Process Sheet

Customer	: CU-DAR001 Dart Helicopters Services	Drawing Name	: AFT TUBE ASSEMBLY
Job Number	: 33846		
Estimate Number	: 10699	Part Number	: D3391025
P.O. Number	: N/A	Drawing Number	: D3391 ~~UNDER REVIEW~~
Date Issue	: 8/8/2007 S.O. No. : N/A	Project Number	: N/A
Sht Rev.	: NC	Drawing Revision	: F
Last Issue	: N/A Type : LANDING GEAR	Material	: N/A
Previous Run	: 33648	Due Date	: 8/15/2007 Qty: 1 Um: Each
Written By	:		
Checked & Approved By	:		
Comment	: Est Rev B 06-02-07 ECN773 dwg rev. D EC		
	Est Rev:C 06-03-28 Update Manufacturing Instructions		
	JLM		
	est rev D 07.03.20 revF dwg ec

From: David Shepherd [dshepherd@dartaero.com]
Sent: August 29, 2007 6:33 PM
To: 'Peter Hum'
Subject: RE: D3391-5 aft tube taper deviation

A-A AND B-B

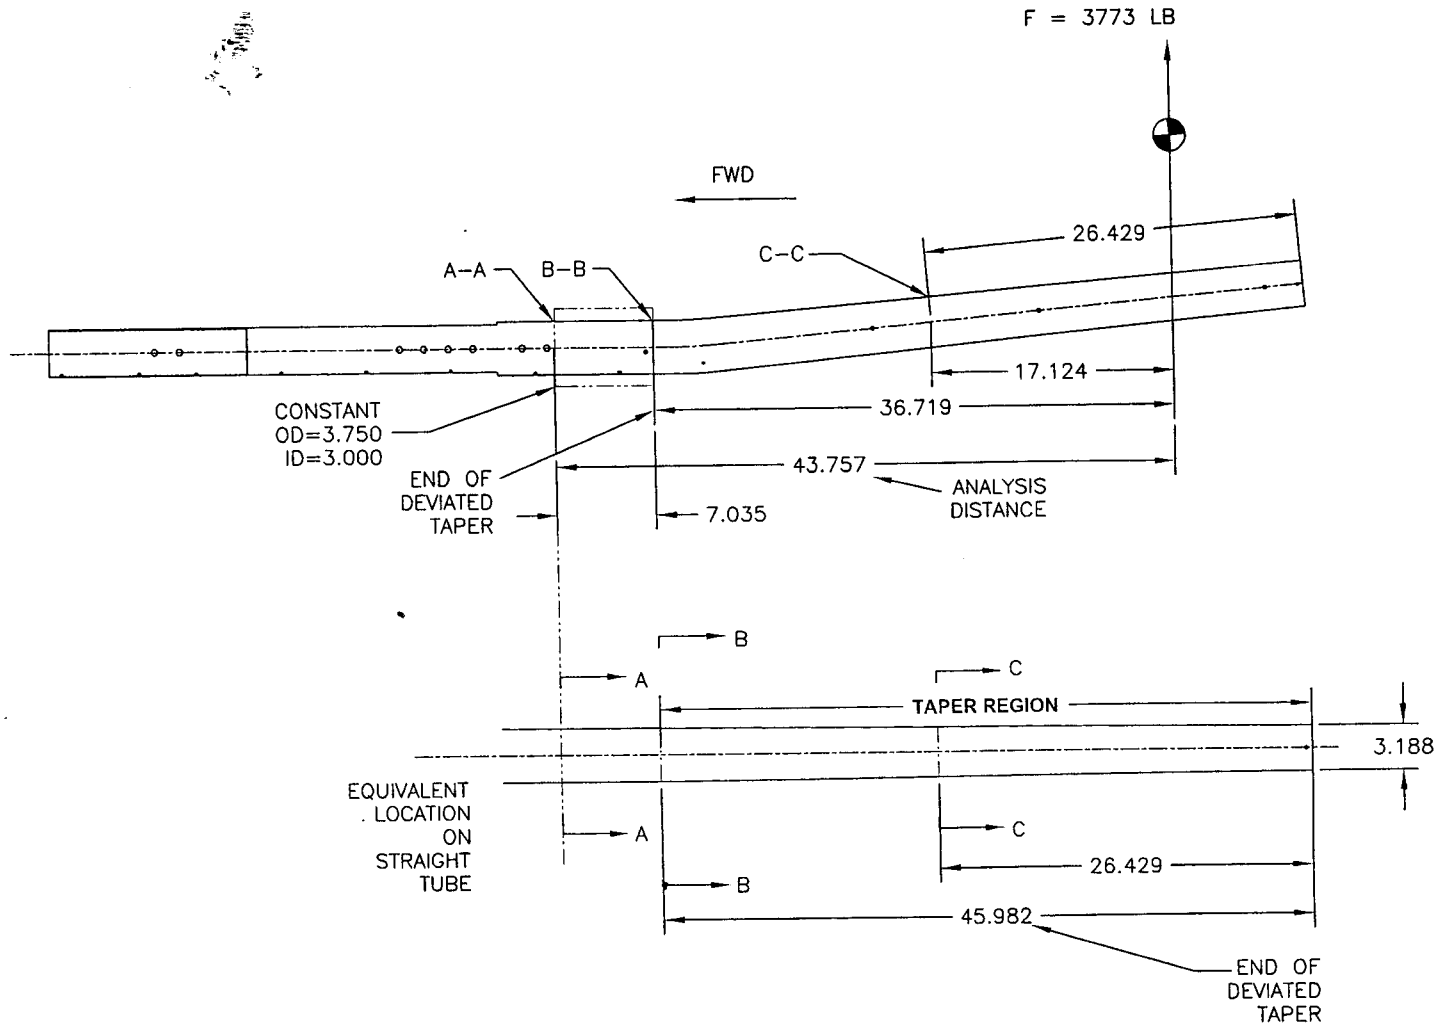
a) The approved analysis we have only takes the section immediately aft of the aft saddle. This is donated by Section A-A in the attached sketch.
b) I took analysis at Section B-B (start of taper) and C-C (mid point of taper) and have shown that these have increasing positive margins. These sections ARE NOT in the approved analysis. I think this would be easier since I can't take analysis at every location on the taper.

I am showing that despite the change in taper, positive margins still exist throughout the skidtube.

I can't tell from what you present in the email if the tube is OK or not.
Do we still have a positive margin of safety everywhere based on our approved analysis?
It might be better to calculate new margins at critical sections in addition to your generalized argument.

Manufacturing is machining a D3391-5 aft tube. The material had chatter marks from the machine. In order to

blend out the chatter marks; the machinist removed more material and extended the taper in order to blend it in to the straight section.

The analysis we have for this area of skidtube is for a point just aft of the aft saddle 43.754". The dimensions are OD=3.750", ID=3.000". Since the taper ends 7.00" AFT of the analysis point the moment will be less here.

The attached analysis shows that the Moment (F*d) decreases FASTER than the decrease of Moment of Inertia (I).

I performed analysis with the deviated taper and it shows that the moment decreases as we go down the taper toward the center of buoyancy of the aft bag; the Moment gets smaller as distance from center of buoyancy gets smaller.

Is this deviation acceptable?

Based on your analysis, I think the deviation is acceptable.

AT A-A
STRESS = MC/I
M=3773 * 57
C=D/2=3.75/2=1.875
I=5.731
STRESS = 54018
YIELD STRENGTH = 57000
MARGIN = (57000/54018)-1
MARGIN = **0.06**

AT B-B
STRESS = 45326
YIELD STRENGTH = 57000
MARGIN = (57000/45326)-1
MARGIN = **0.26**

AT C-C
STRESS = 32599
YIELD STRENGTH = 57000
MARGIN = (57000/32599)-1
MARGIN = **0.75**
